SERVICE BULLETIN

APPLICABILITY: 2019-21MY Forester
 2018-21MY Crosstrek

NUMBER: 12-299-20R

SUBJECT: 6/8-way and Driver's Seat Hinge Cover-
 Design Change

Enlarged View of Damaged Claw

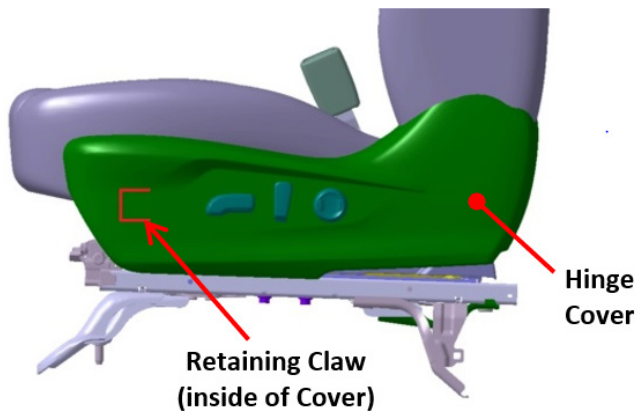
This bulletin announces a design change made to the outer hinge cover on the driver's 10-way adjustable power seats. The change has been made to address several reports about the cover coming loose over time as a result of getting into and out of the driver's seat. The retaining claw portion securing the cover to the seat frame has been changed to improve its strength and durability.
